Martinique Mining Corporation

RE: file # S0170043 task number 2827

The following is our response to a list of questions given us by Paul Baker concerning our May Day Mill site amended notice sent to your office on January 7th, 2009. We are very sorry for the incomplete information provided and hope that our following response will fill the gaps for your file.

Subject: Deficient Amended Notice of Intention to Commence Small Mining Operations, Crescent Creek
Mayday Mill, S/017/043, Garfield County, Utah

MARTINIQUE MINING CORP.
MAY DAY MILL SITE TEST PLANT

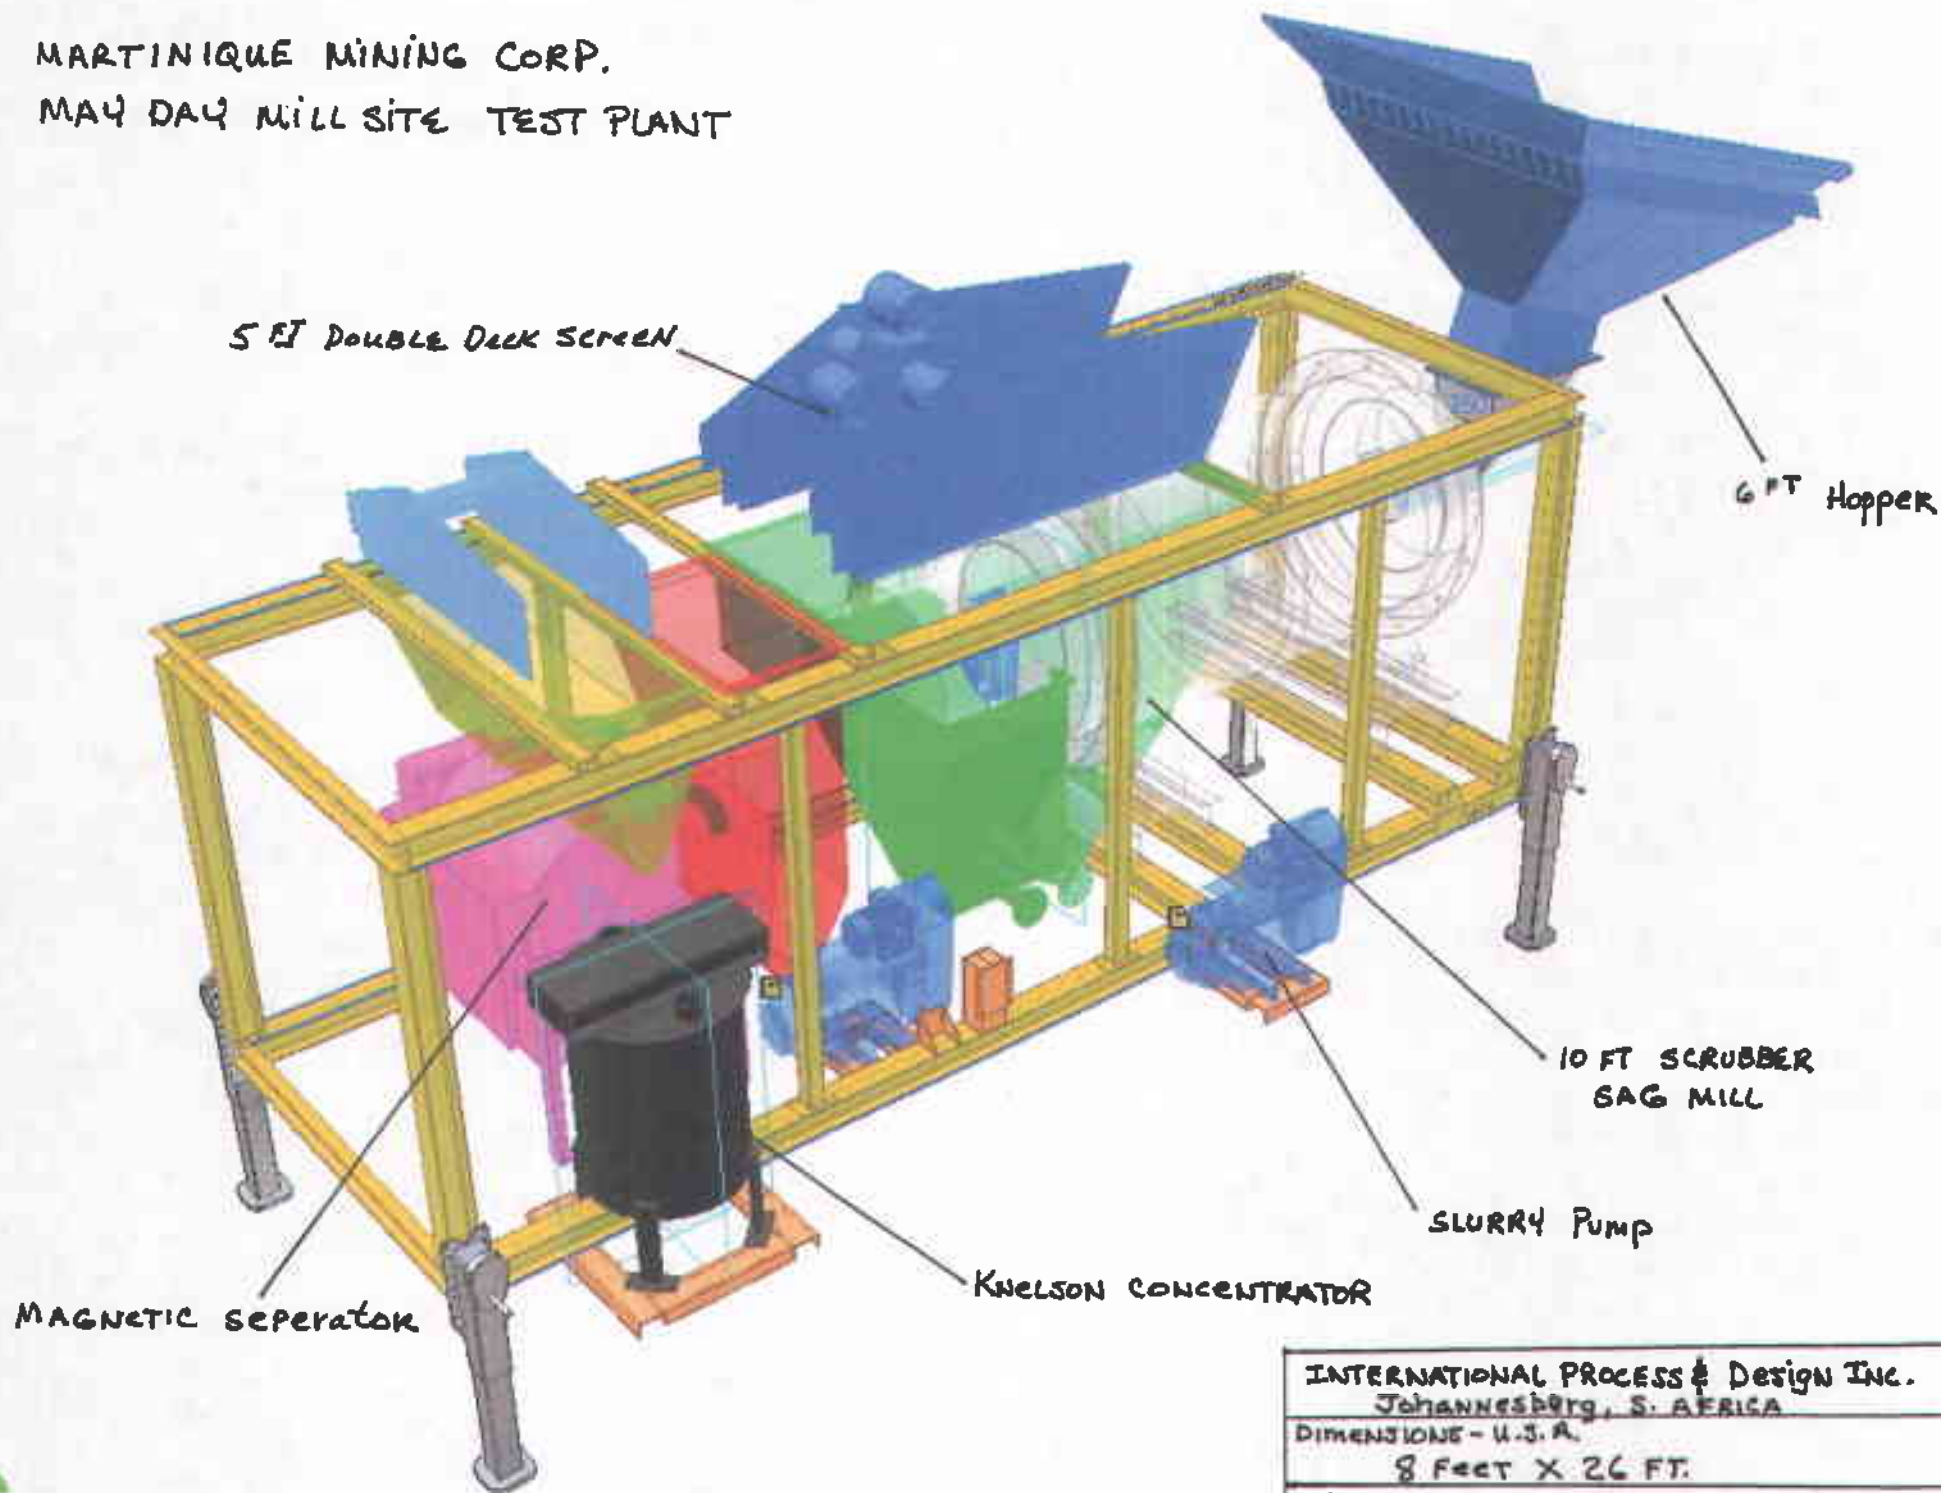
- The height of the building.
- Dimensions for concrete, floors and footers.
- The type of material used for building construction: steel, concrete, masonry, mixed.
- Estimated weight of equipment that would have to be removed from the site at reclamation.
- Dimensions and type of storage tanks and other structures that would have to be removed from the site at reclamation. **ANY STORAGE TANKS (MOBILE & FIXED)**
- Location and distance to a disposal site for equipment and building debris. Note: the Division will allow you to ship steel to a reclaim facility that will accept the material for no cost.
- The maximum amount of material that will be stored on site.

6. **The weight of the test plant itself is 20,000 LBS. or 10 tons. The unit is of modular construction and requires 1 standard flat bed truck for transport. Please refer to our provided diagrams for all dimensions and weight scales.**
